**RESPONSE TO SUBMISSIONS  
7 RAILWAY STREET, CHATSWOOD**

We write to you on behalf of Mirvac Projects Pty Ltd and thank you for the opportunity to respond to the submissions that were received in the relation to section 75W modification application (MP09-0154 Mod 1).

Figure 1 – Aerial photo of Railway Street

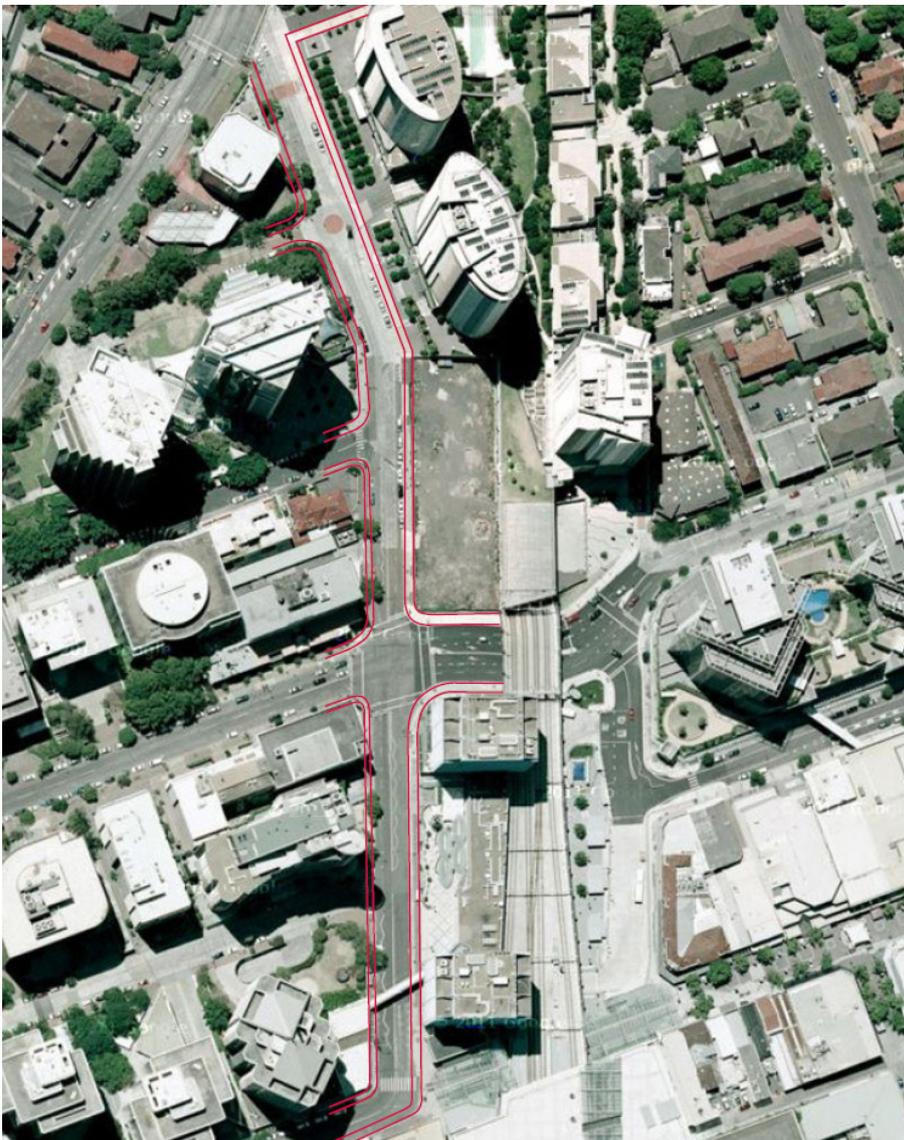
As noted in the original submission there are no street trees within the footpath along the eastern side of Railway Street as can be seen in the aerial photo at **Figure 1**. Rather trees have been set back within the property boundary as can be seen in the photo at **Figures 2 and 3**. The provision of trees within the property boundary as opposed to the footpath will not have any discernable impact on the appearance of the streetscape as a green edge is still proposed within the site consistent with the remainder of the street.

During the development of the Epica and Altura buildings to the north it was discovered that a sensitive fibre optic cable is located under the footpath on the eastern side of Railway Street (refer to letter from WEBB Australia at **Attachment B**). Disconnection of this line causes lost revenue in the order of \$1 million per day as this is the cable that the fibre optic networks of Sydney and Brisbane.

The fibre optic cables are currently installed in their dedicated service pit within the road verge as shown on the plan at **Attachment B**. If these cables were to be relocated out of the approved tree trench area the only other location they could be placed is within the dedicated allotment for gas mains. This is unlikely to be approved by Telstra due to the potential for future conflicts with the gas authority and also the lost revenue whilst the cable is disconnected for several days.

Due to the sensitivity of these cables, it would be unwise for trees to be planted anywhere above or adjacent to the cables as the tree roots could cause damage to the Fibre Optic network. As they would be located on public property this would become the responsibility of Council as opposed to the owners corporation of 7 Railway Street. The revised scheme, which proposes the planting of trees above the basement carpark, would separate the proposed trees from the services in the street and would thus prevent such a situation from occurring.
